PORT ST. VRAIN NUCLEAR GENERATING STATION

AMENDMENT TO FACILITY OPERATING LICENSE

Amendment No. 13
License No. DPR-34

ATTACHMENT TO LICENSE AMENDMENT NO. 13

AVERAGE CORE OUTLET TEMPERATURE, °F. (Fig. 4.2.11-1)

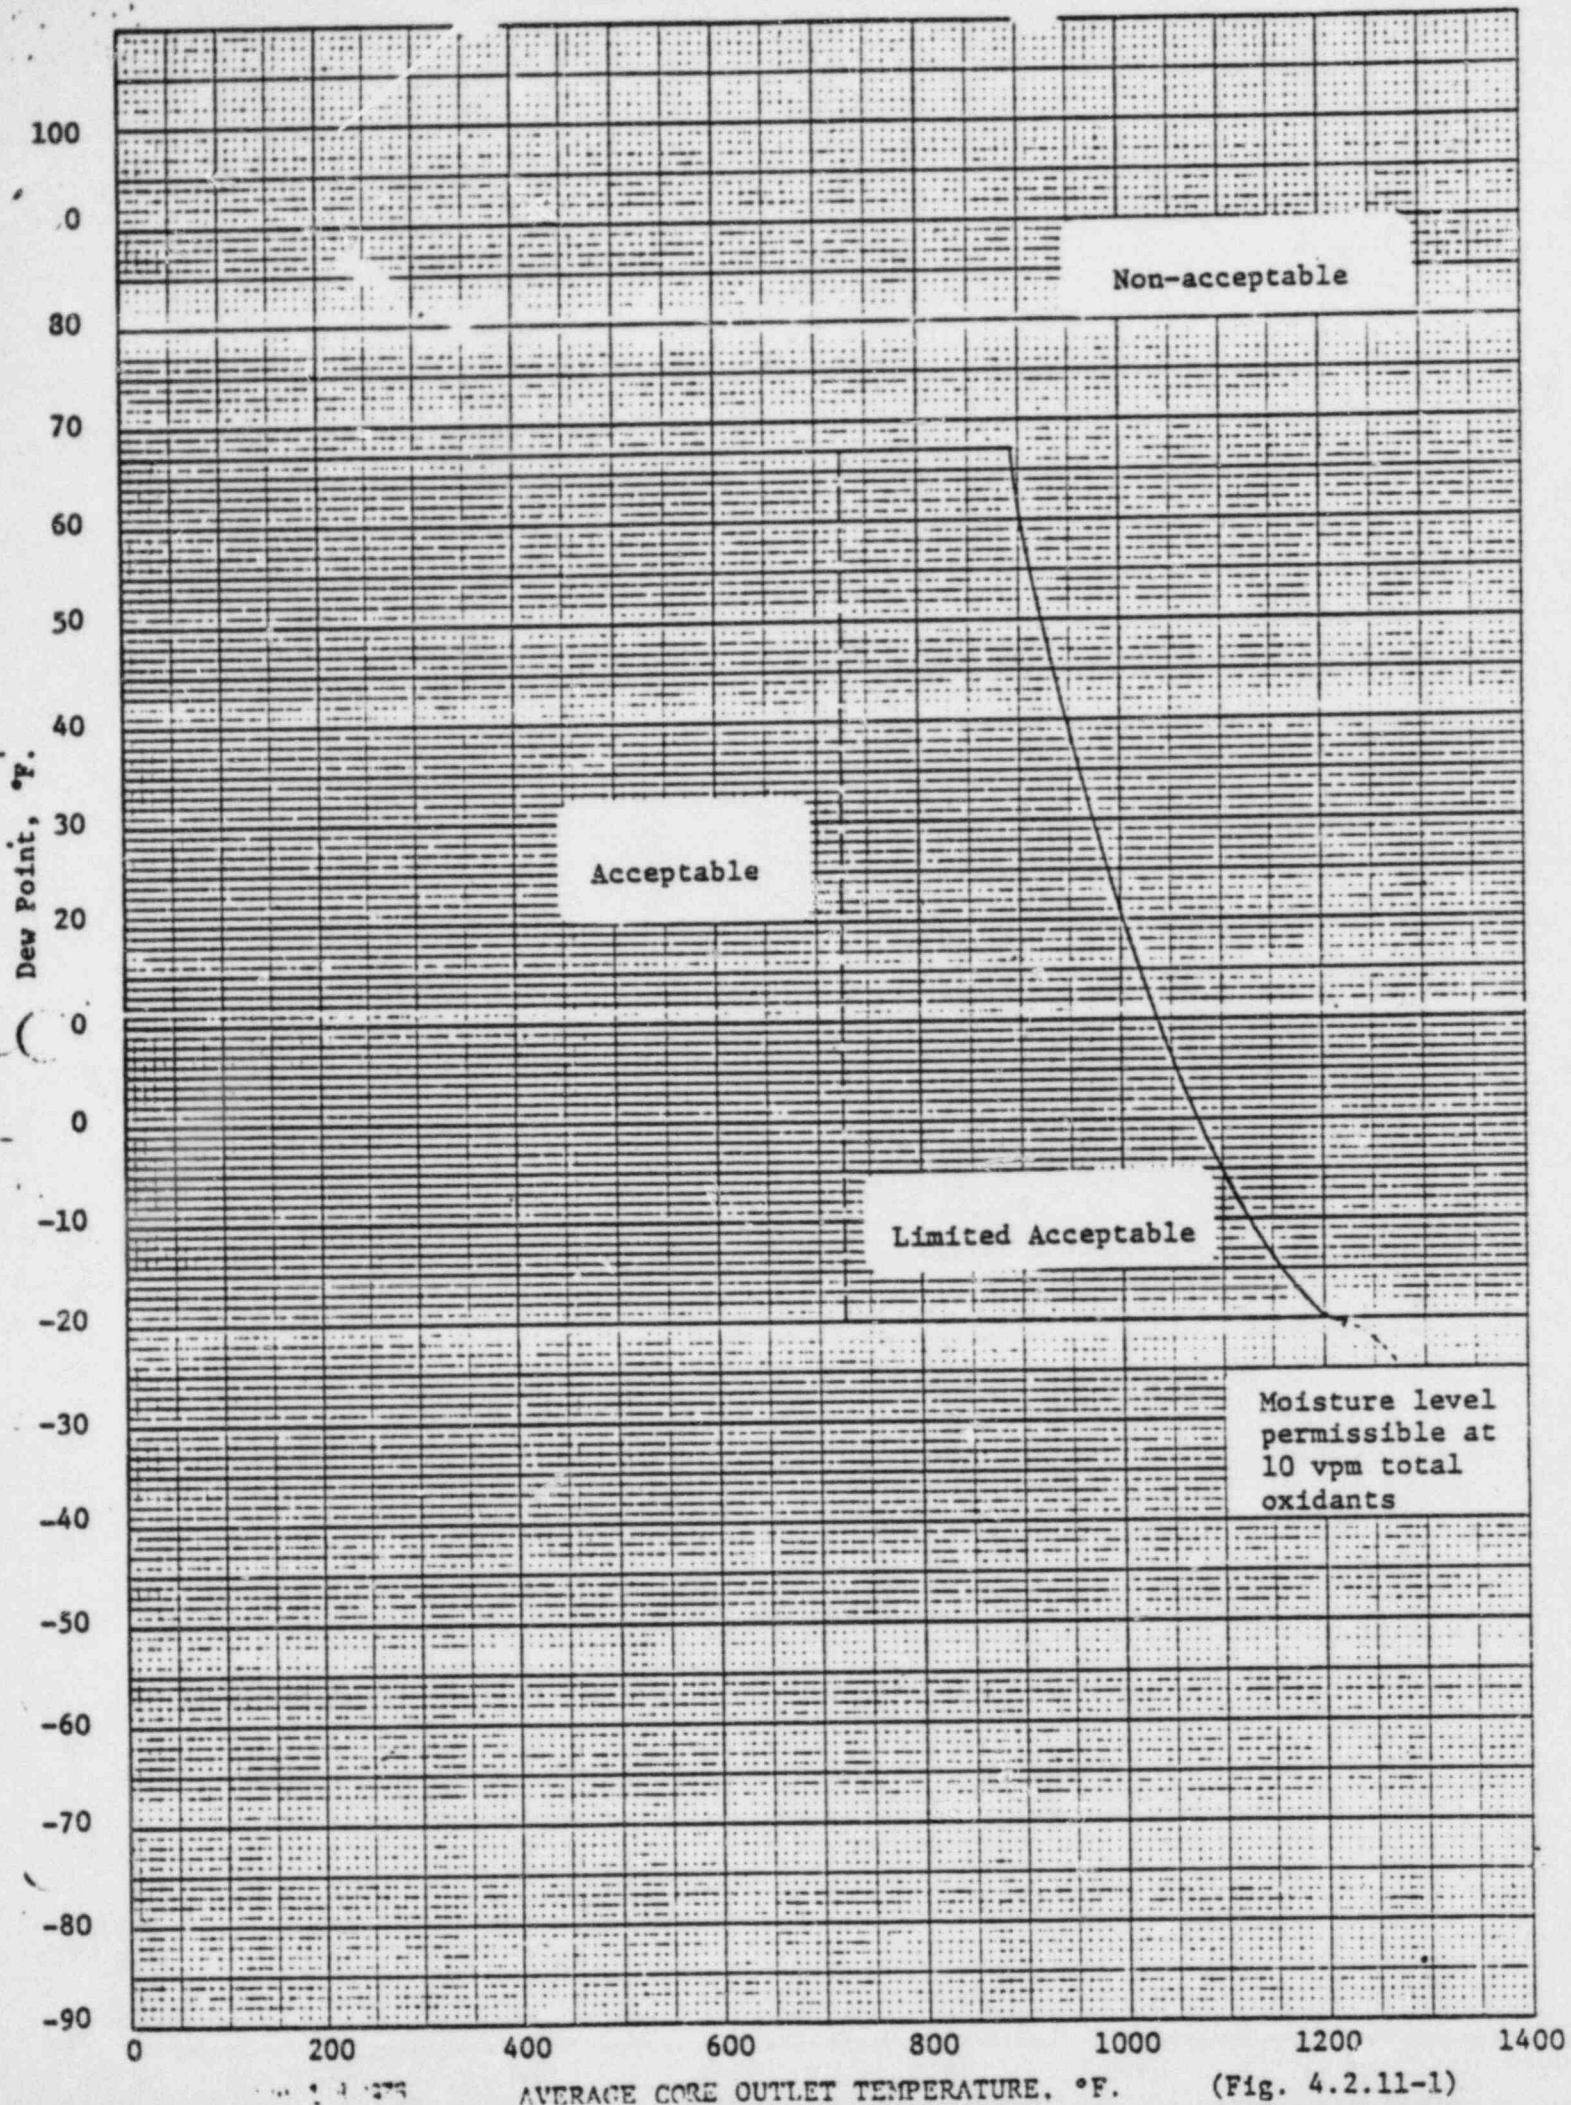
H_2O - dew point limits as a function of average core outlet temperature given in Figure 4.2.11-1.

In addition to those limits above, during reactor startups and shutdowns, the total time when reactor average outlet temperatures are between 725°F and 1200°F, and the moisture dew point is higher than -20°F shall not exceed a total of 90 days during any one refueling cycle.

The criterion used to establish the limits of Figure 4.2.11-1 in the range from 725°F to 1200°F was that not more than 10% of the beginning of life (BOL) B can be present as oxide over a refueling cycle. This criterion is based on the BOL B worth of 0.06 Δk , and the fact that 10% worth, 0.006 Δk , is substantially less than the minimum core shutdown margin of 0.016 Δk (FSAR Section 3.5.3.1), and only one-half of the reactivity anomaly of 0.012 Δk specified in Technical Specification SR 5.4.1.

The stipulation used in developing the curve of Figure 4.2.11 is that with the reactor outlet temperature in the range between 725°F and 1200°F, and with a primary coolant dew point temperature higher than -20°F, operating time under these conditions would be limited to no more than 90 days over any refueling cycle. By combining this stipulation with the dew point limits shown in Figure 4.2.11-1 for this temperature range, the criterion that no more than 10% of the BOL B^{10} will be present as oxide during a refueling cycle is met.

The dew point limit of 67°F below 725°F average outlet temperature was selected to prevent corrosion of metal parts. It is an effective limit since all metal parts within the PCRV exposed to primary coolant are maintained at or above 75°F.
